Re: Rainier Commons, LLC – Old Rainier Brewery Exterior Paint Abatement
Phase II Individual Phased Work Plan (IPWP) – Supplement No. 3 - for South
Wall of Building 15 only

I. General Clarifications and Supplements for South Wall of Building 15 portion of Phase II Work.

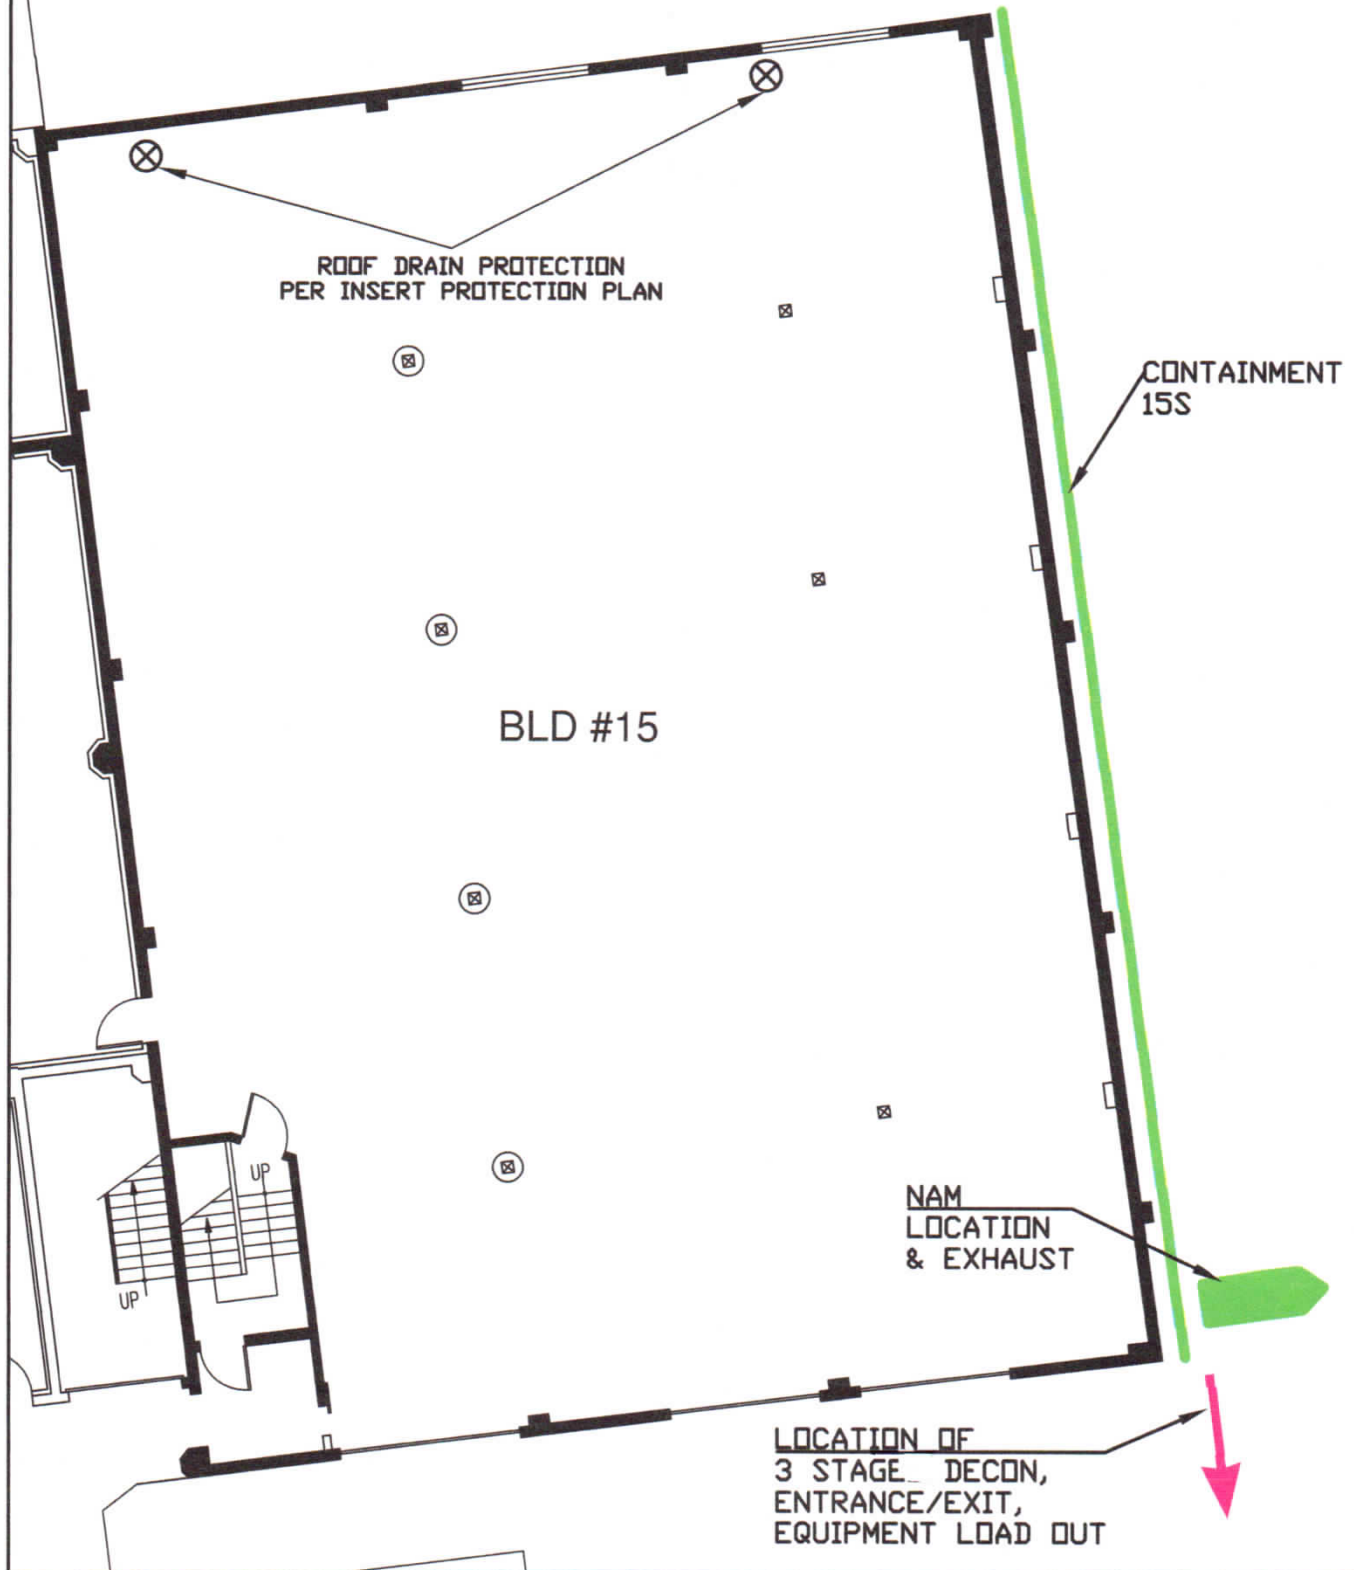
2. Your workplan states that the roof drains and inlets are not near the location of blasting. You agreed to submit photographs demonstrating this. The roof inlets are capped and also have filter fabric in place already.

The attached photographs depict the two roof drain locations, which are outside the NPE for Building 15's south elevation abatement work.

BLDG 15 - FACING SOUTH

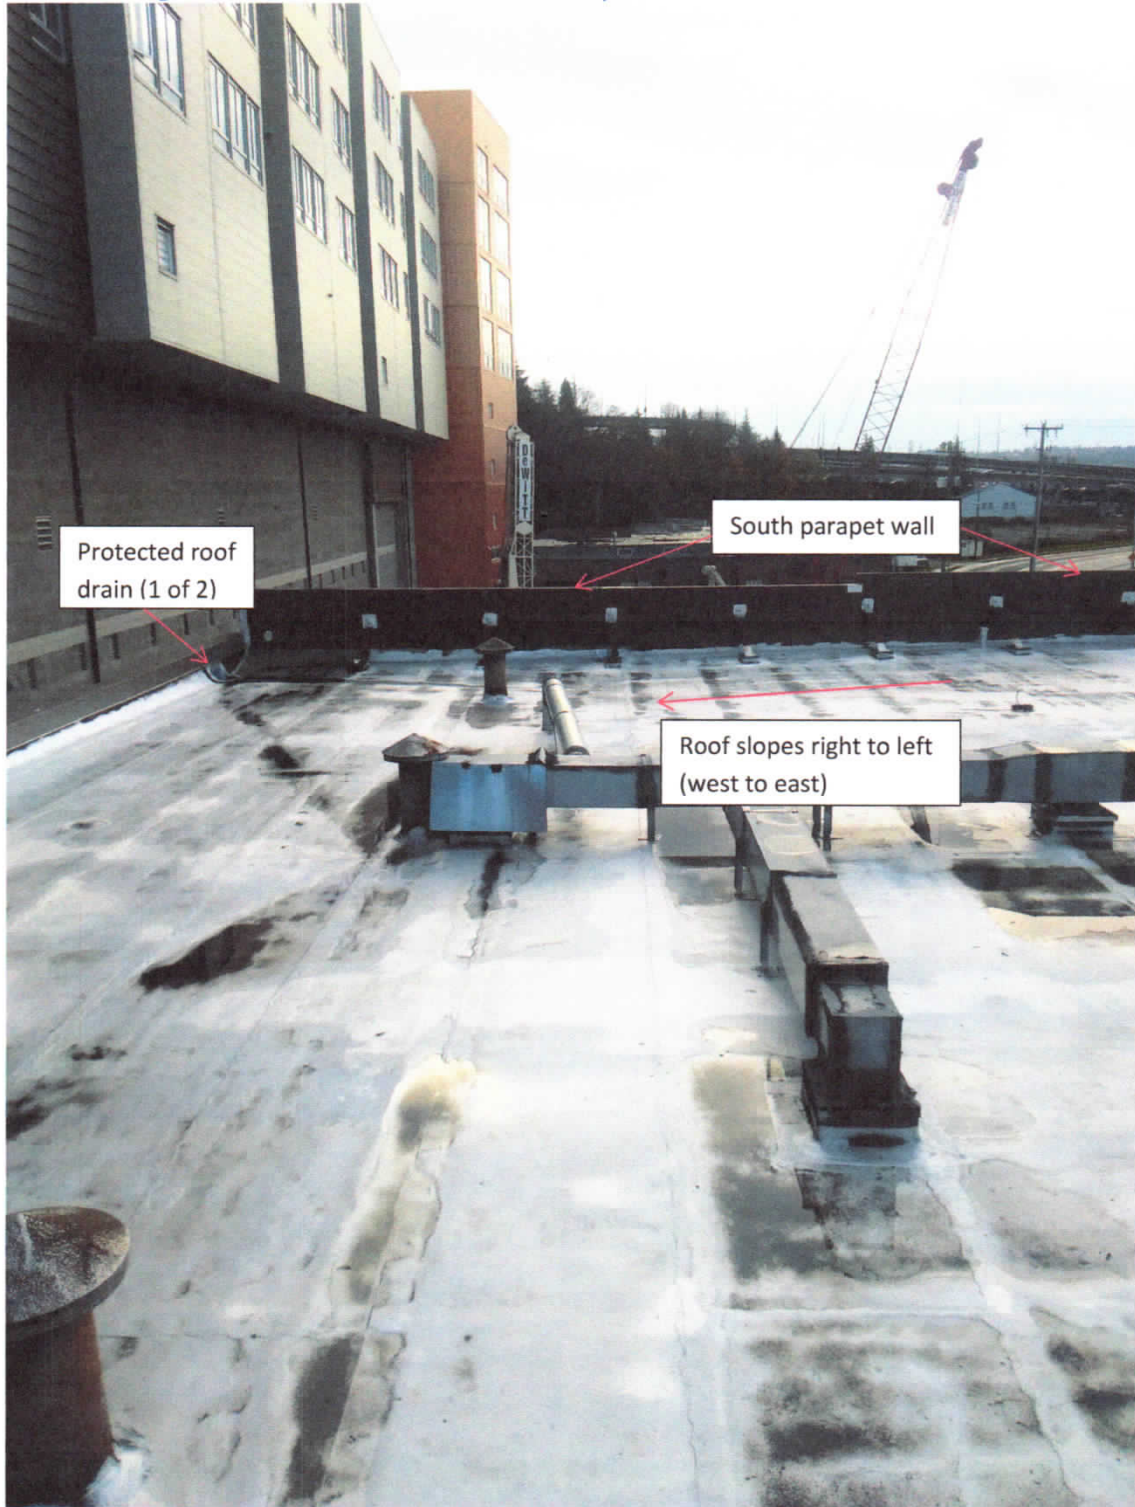
12. Exhibit 9 contains a figure that shows the containment structures, location of the NAMs and decon/equipment load out areas, and location of roof inlets with protection plans. Please provide a similar diagram for Building 15.

The attached "Supplement to Exhibit 9 Site Plan" is incorporated by reference.

BLDG 15 LEVEL 200 SOUTHWEST QUADRANT

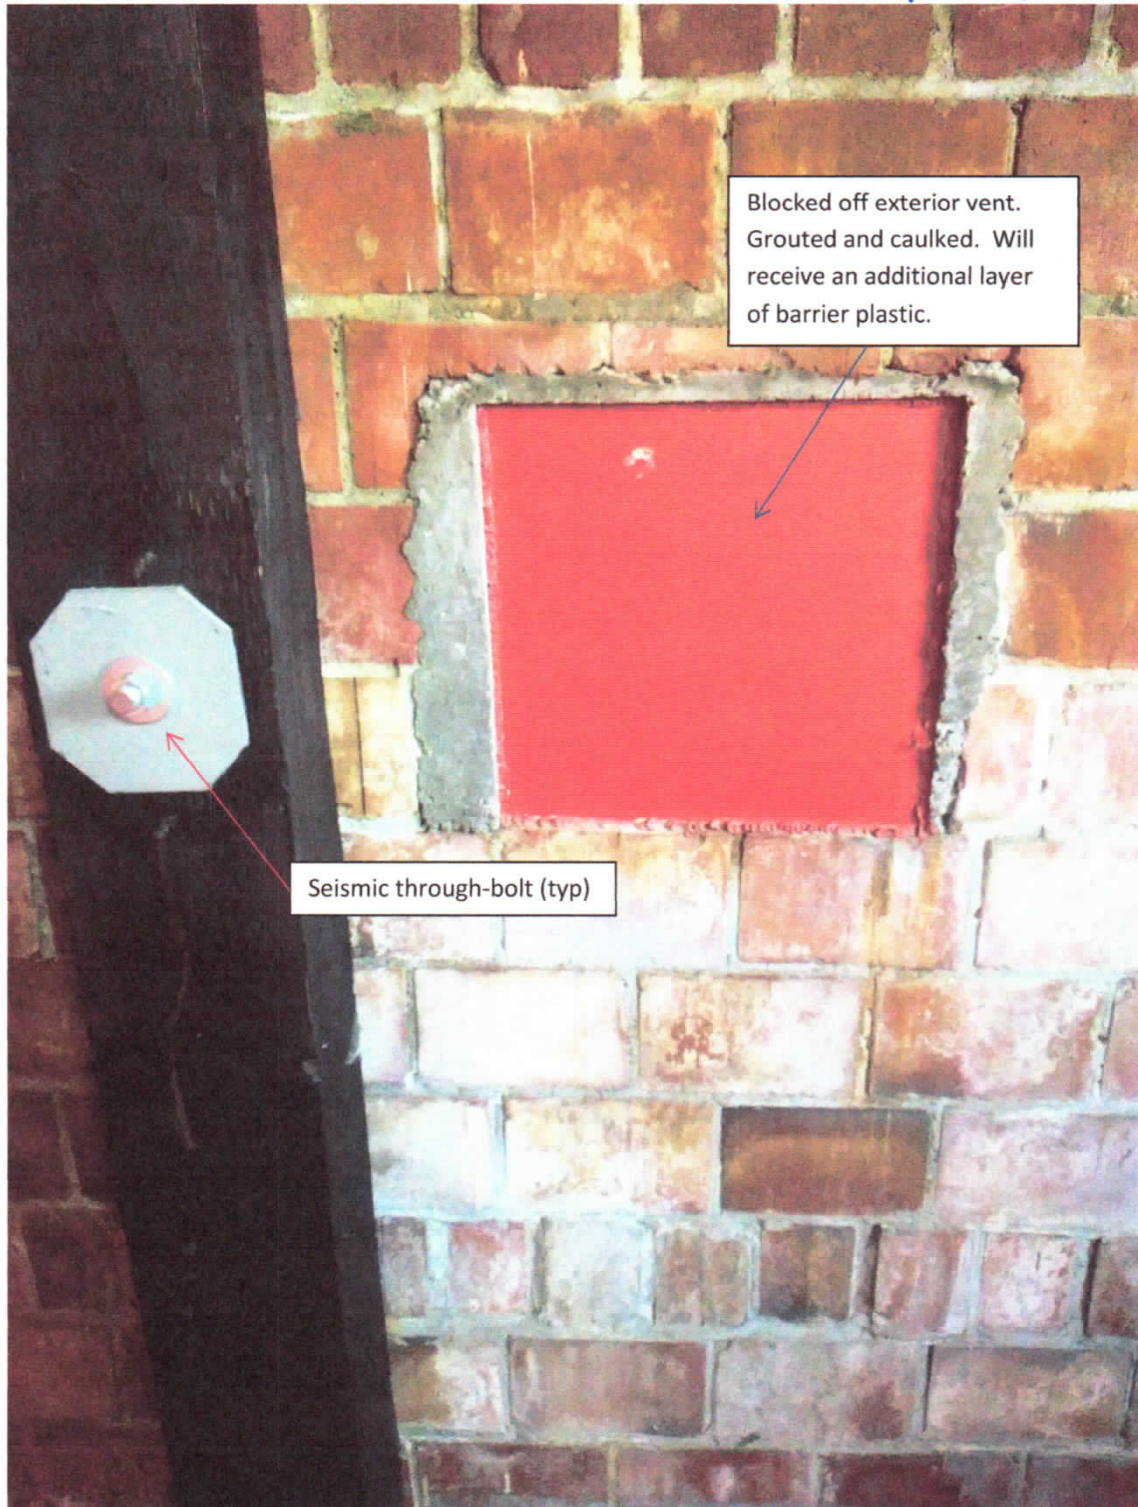
1. Building 15 has one metal vent on the side. It is blocked on the inside by sheet metal. You agreed to seal the vent, and seismic bolts, and the door, and any other point of ingress on the inside of the building. These will be individually sealed, in addition to the poly-sheeting across the entire wall surface.

After further site review with CGI, it was determined that the most efficient and comprehensive protection for these multiple locations is to treat the entire interior wall surface with "critical barrier" protection as described in item 5, above.

Blocked off exterior vent.
Grouted and caulked. Will
receive an additional layer
of barrier plastic.
